ADDENDUM # 1

November 5, 2021

**Bataan Lift Station Renovation
Bid No. 2021-09**

Bohannon Huston Inc.

BHI PROJECT NO. 20210255	DWG NO. C-900R	SHEET OF 11	DATE 29
-----------------------------	-------------------	----------------	------------

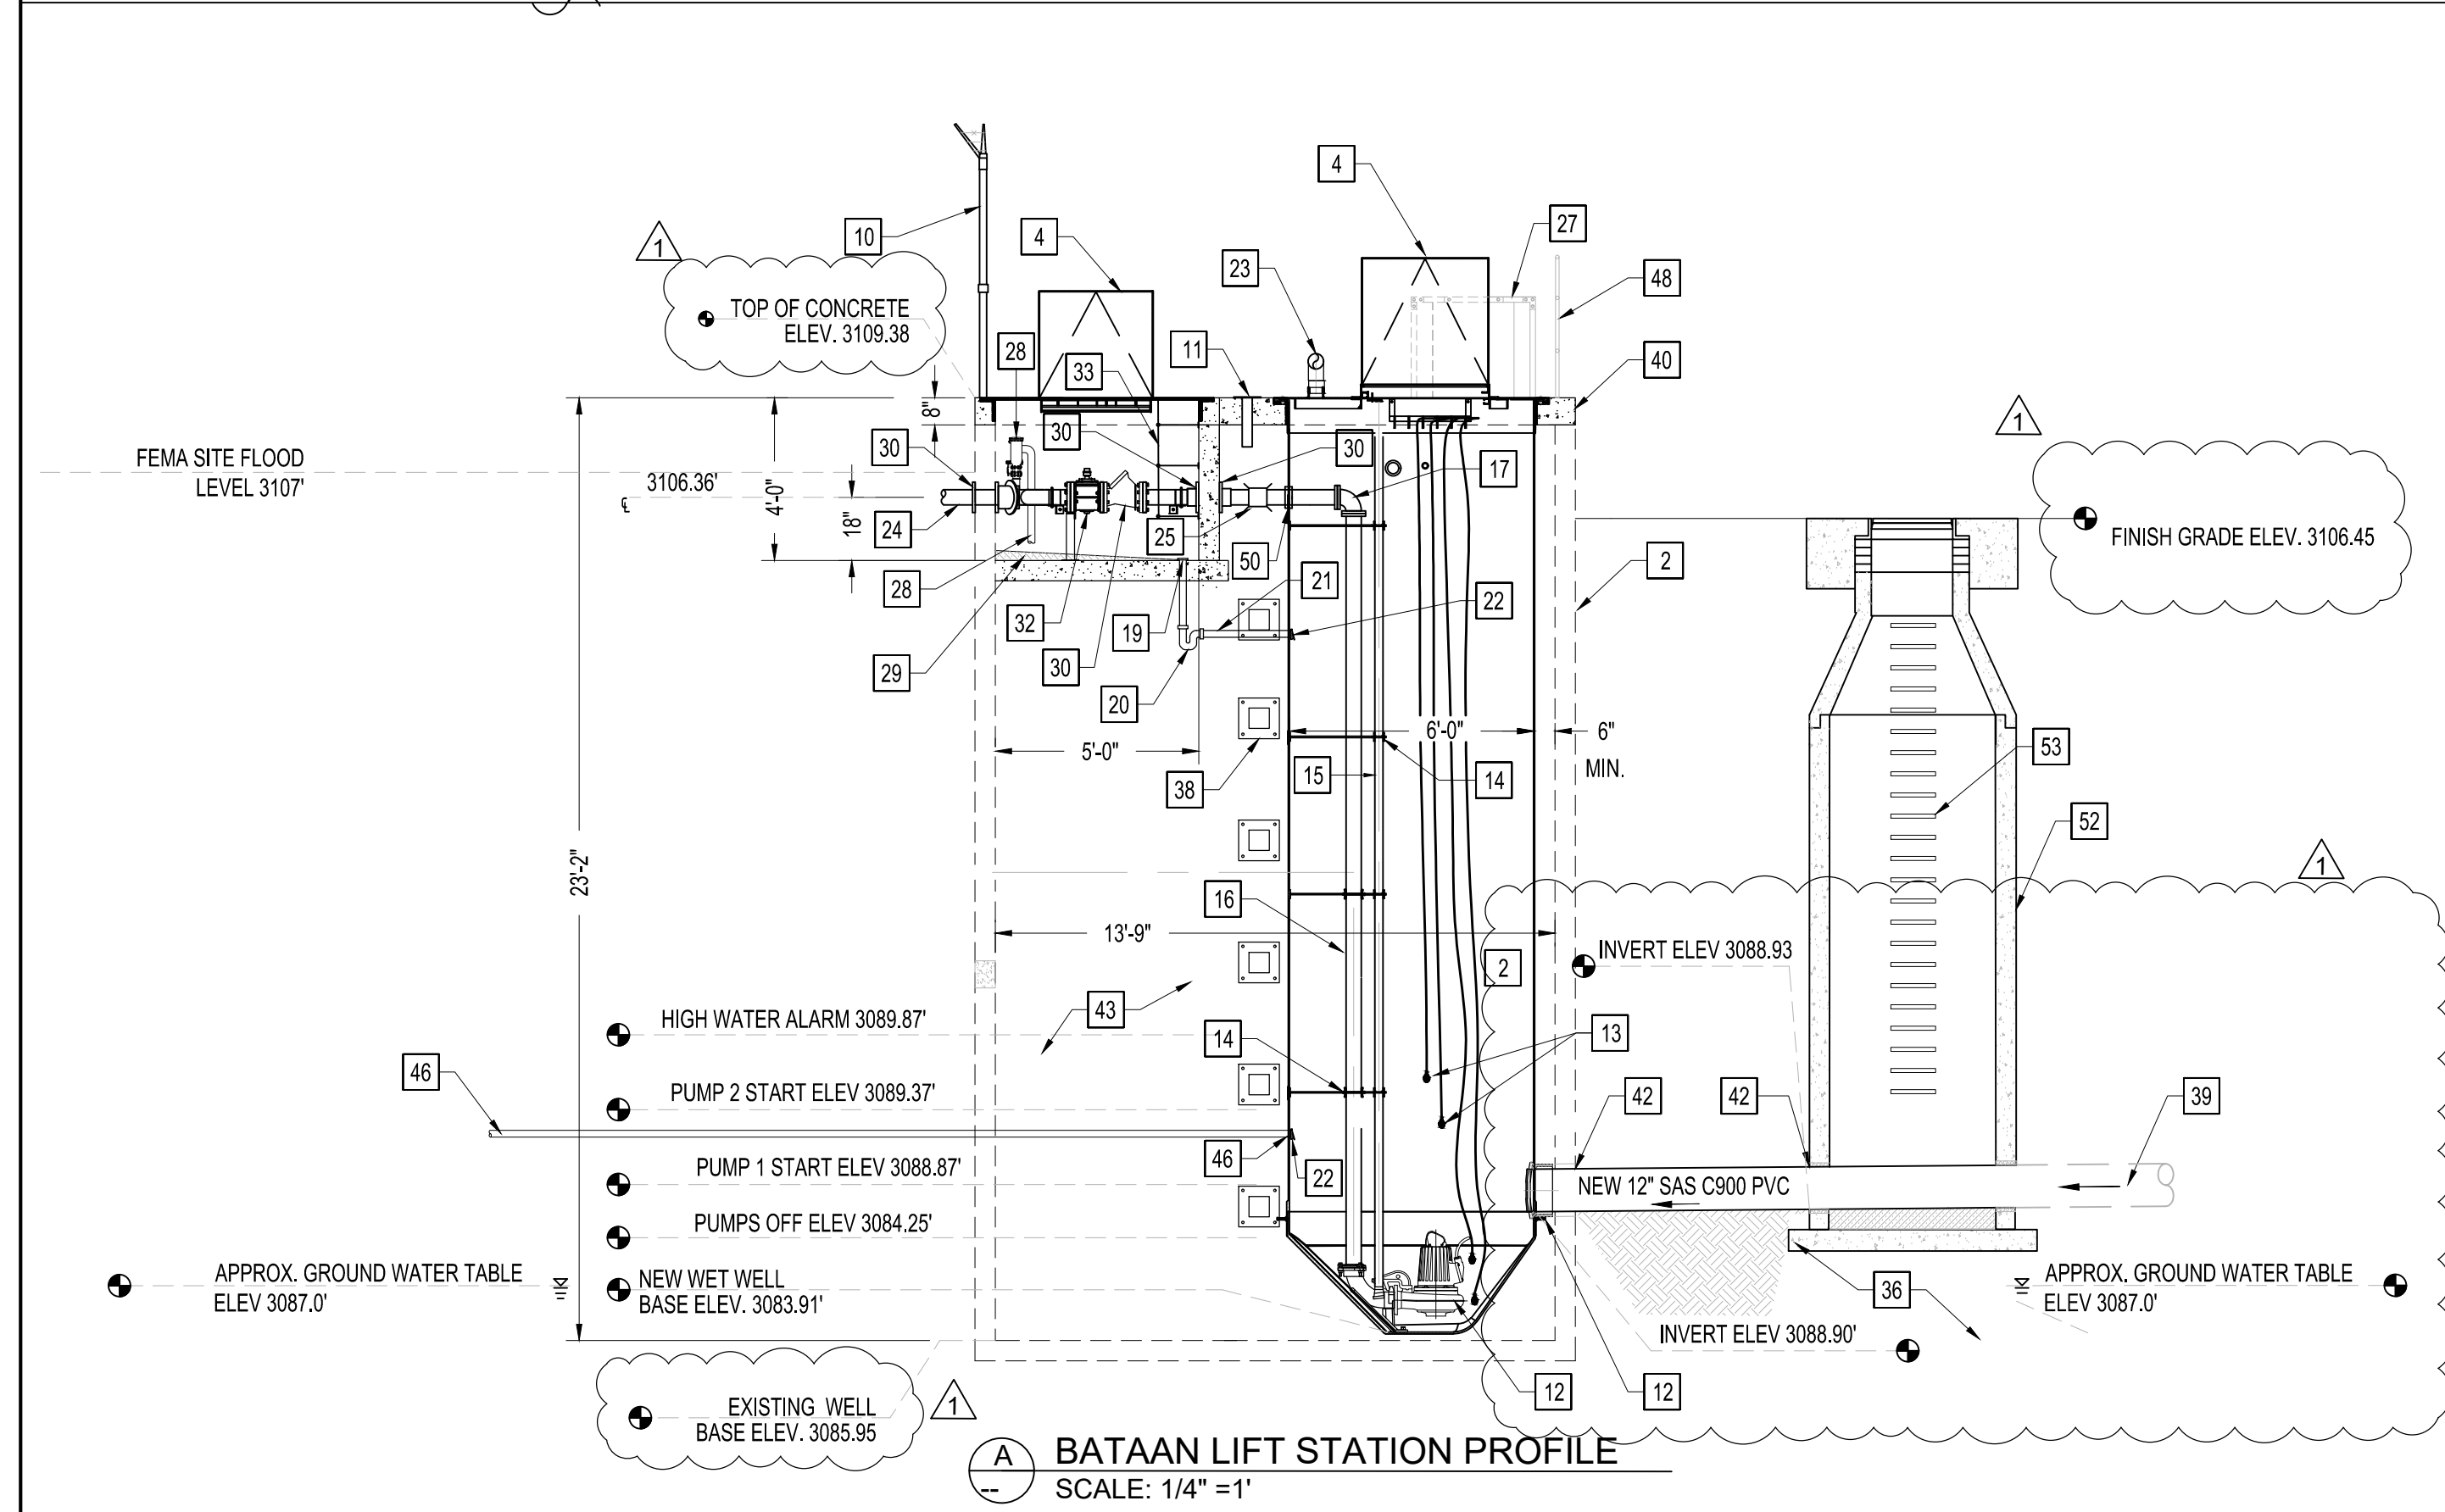
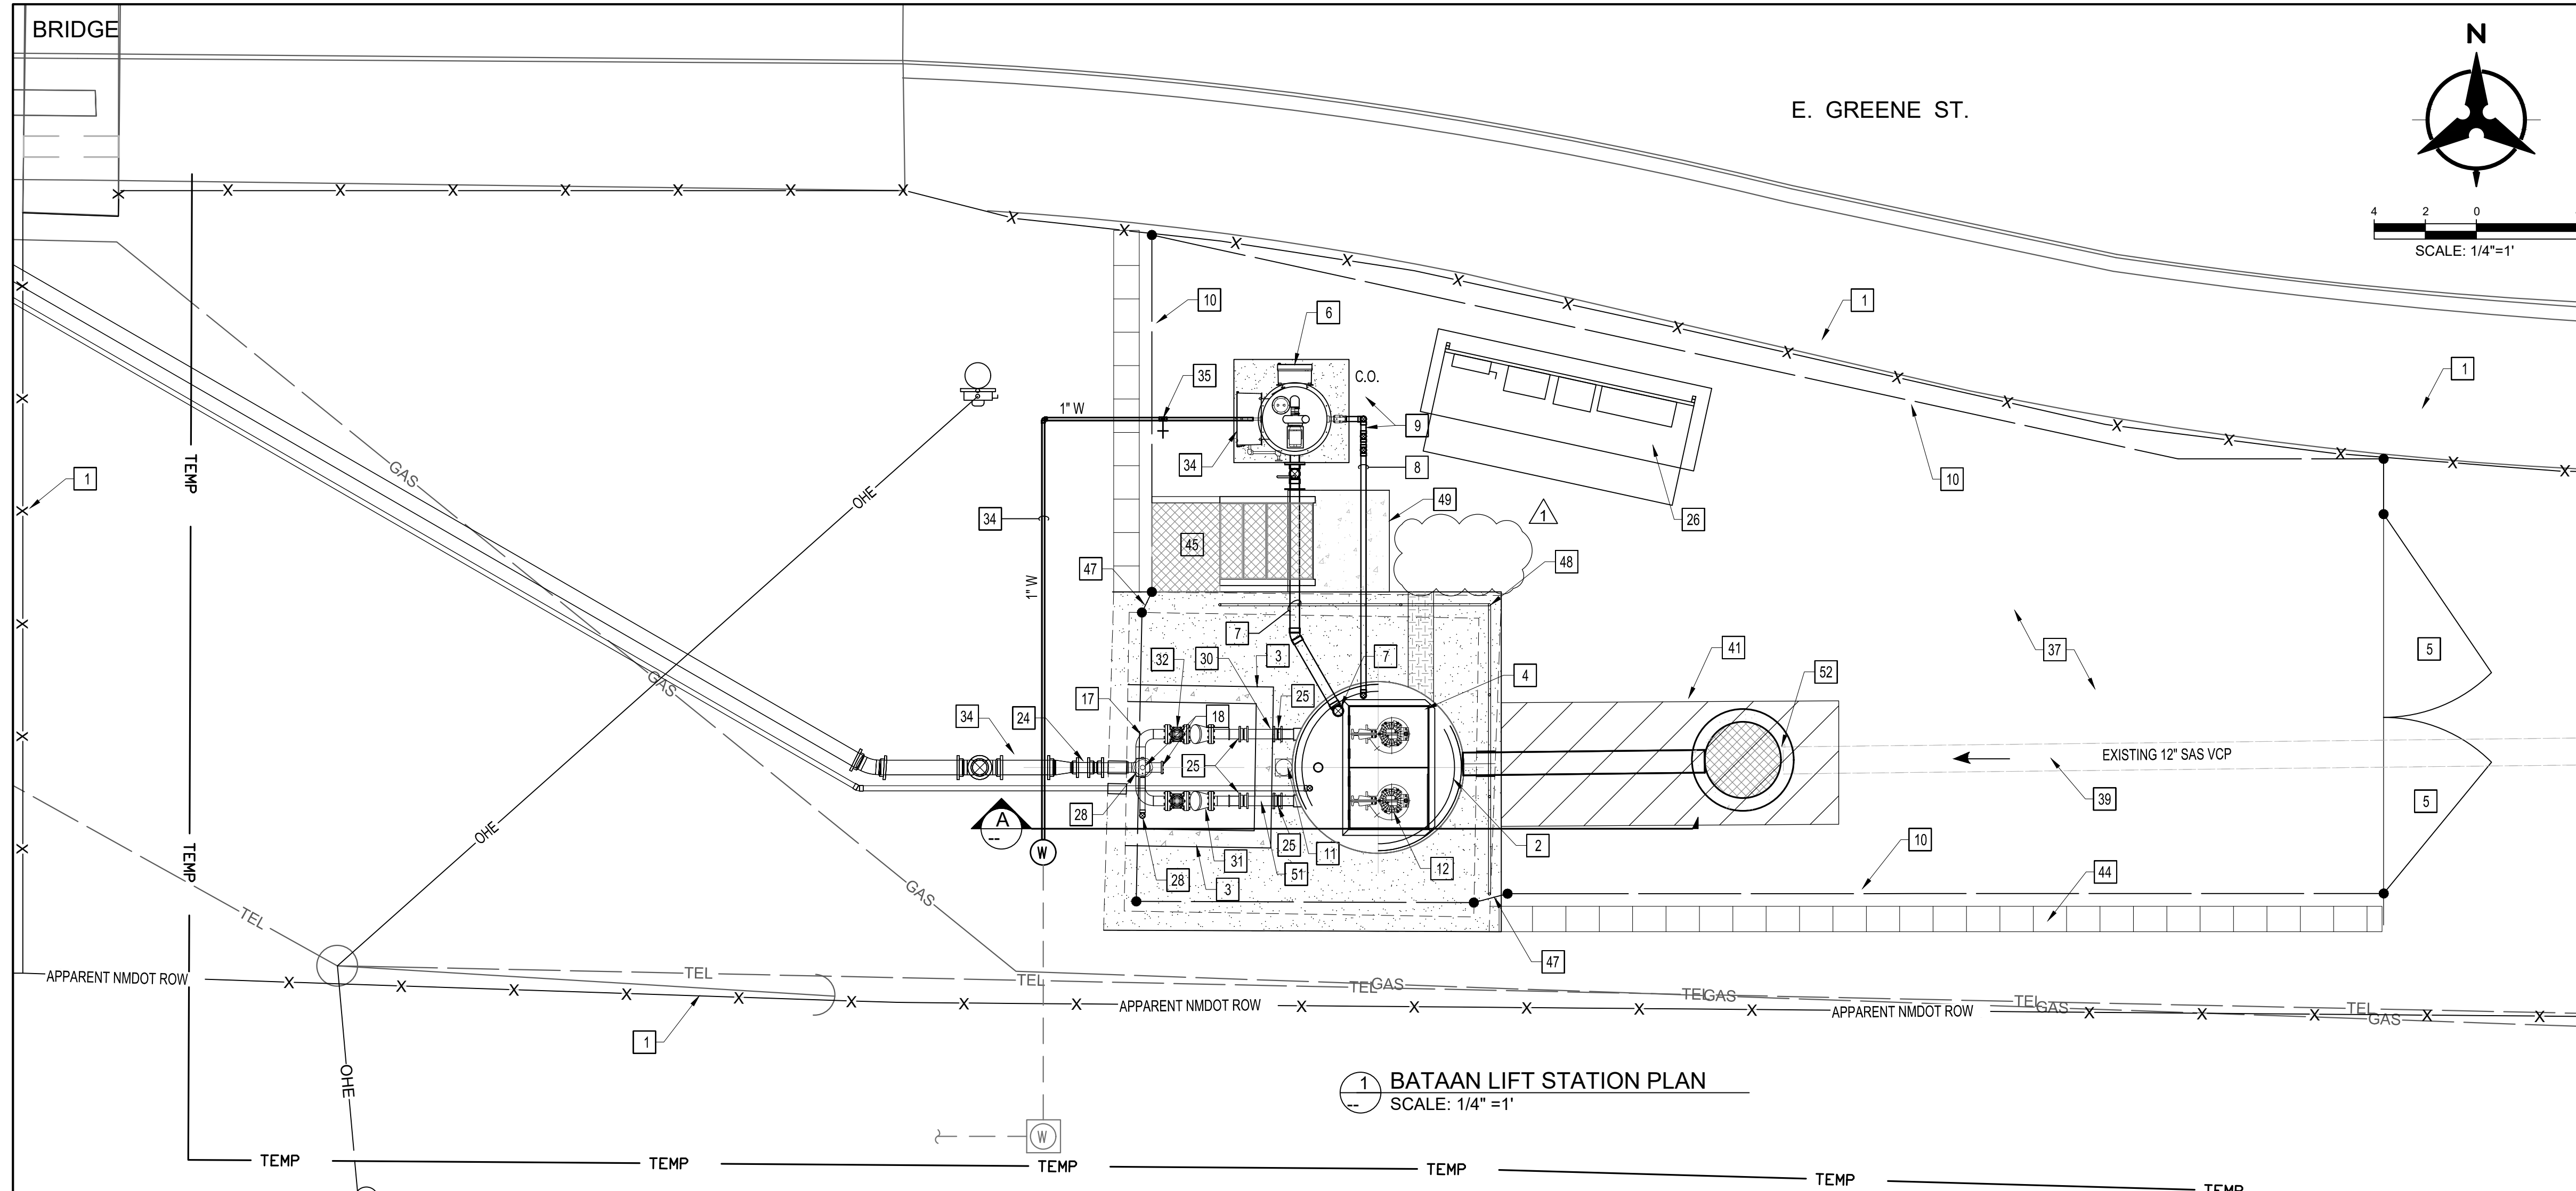
3. **Question:** Section A Sheet C-900, calls for 12” SAS C900 pipe, while Key Note #42 calls for 12” DWV SAS Pipe, furthermore Spec 02722, 2.01, B calls for SDR-35. Please clarify the type of SAS Pipe required in this location.

1. **Drawing C-500-R1**: Revised elevation data and corrected station depth dimensions.
2. **Drawing C-800-R1**: Revised elevation data.
3. **Drawing C-900-R1**: Revised elevation data and corrected station depth dimensions.

Answer: All Gravity sewer main shall meet ASTM D3034 Standard Specification for PVC Sewer Pipe and Fittings, the new 12-inch diameter pipe shall be SDR-35. See revised sheet C-900R.
